WETT RECOMMENDED INSPECTION CHECKLIST

Requested by: <u>All Max Home Inspection</u>	Inspection location: ☐ Same as requested or:
Address: <u>7851 Dufferin St #500</u> <u>Concord, ON</u> <u>L4K 1R6</u>	Address: <u>526 Sandford St</u> <u>Newmarket, ON</u>
Email: <u>info@allmaxhome.ca</u>	Email:
Phone No.: <u>416 995 9960</u>	Phone No.:
Inspector's name: <u>Shawn Jones</u>	WETT No.: <u>10705</u>
Reason(s) for inspection: <u>pre listing Assessment</u>	
Level of inspection requested: ☒ Level 1 ☐ Level 2 ☐ Level 3	
Date of request: _____	Date of inspection: <u>Aug 26, 2025</u>

FACTORY-BUILT CHIMNEY

526 Sanford St – Birds Nesting Inside Stove Interior

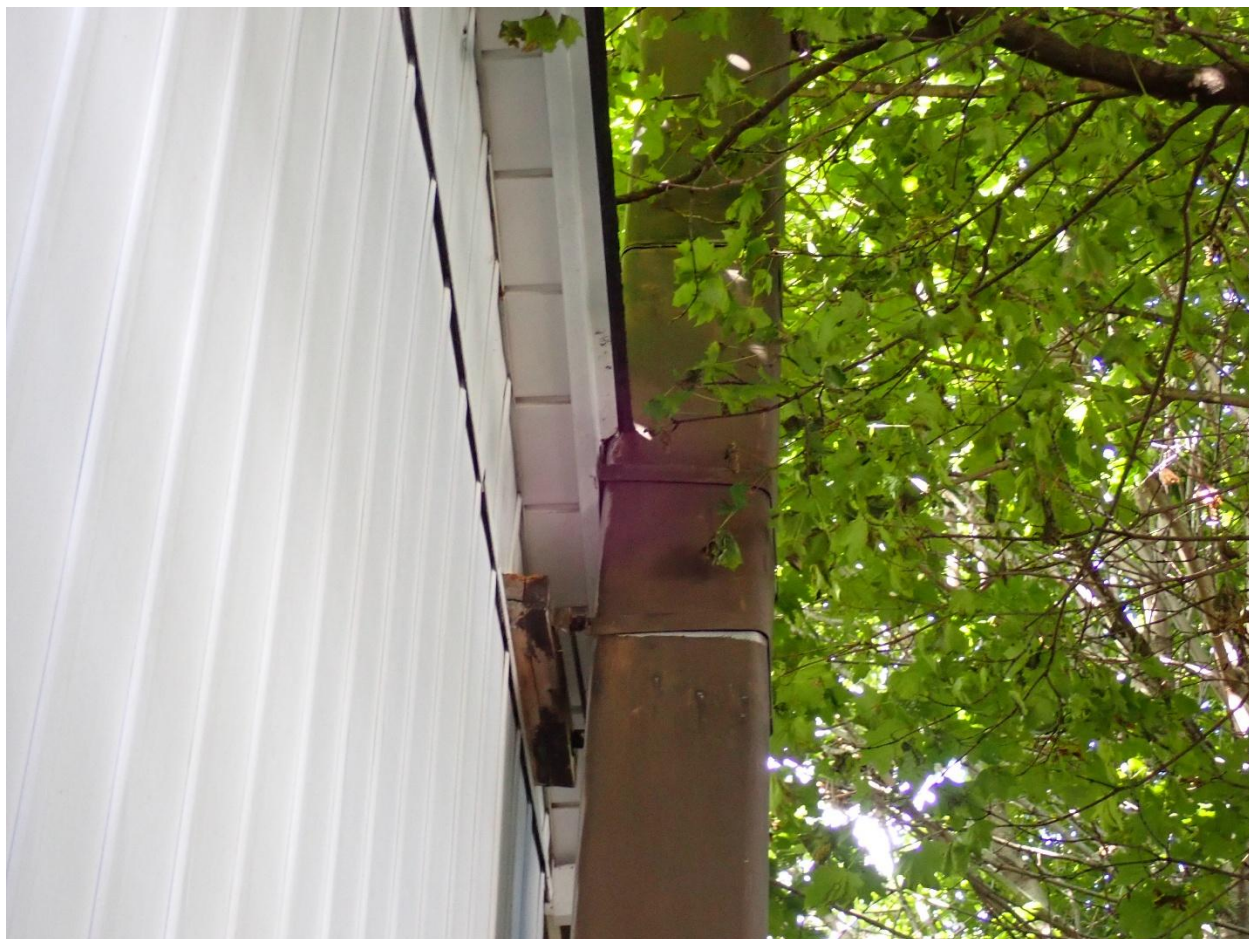
A birds nest was noted inside the firebox. It appears that birds have been able to enter the chimney. A level 2 wet inspection is required to examine the chimney interior for blockages.
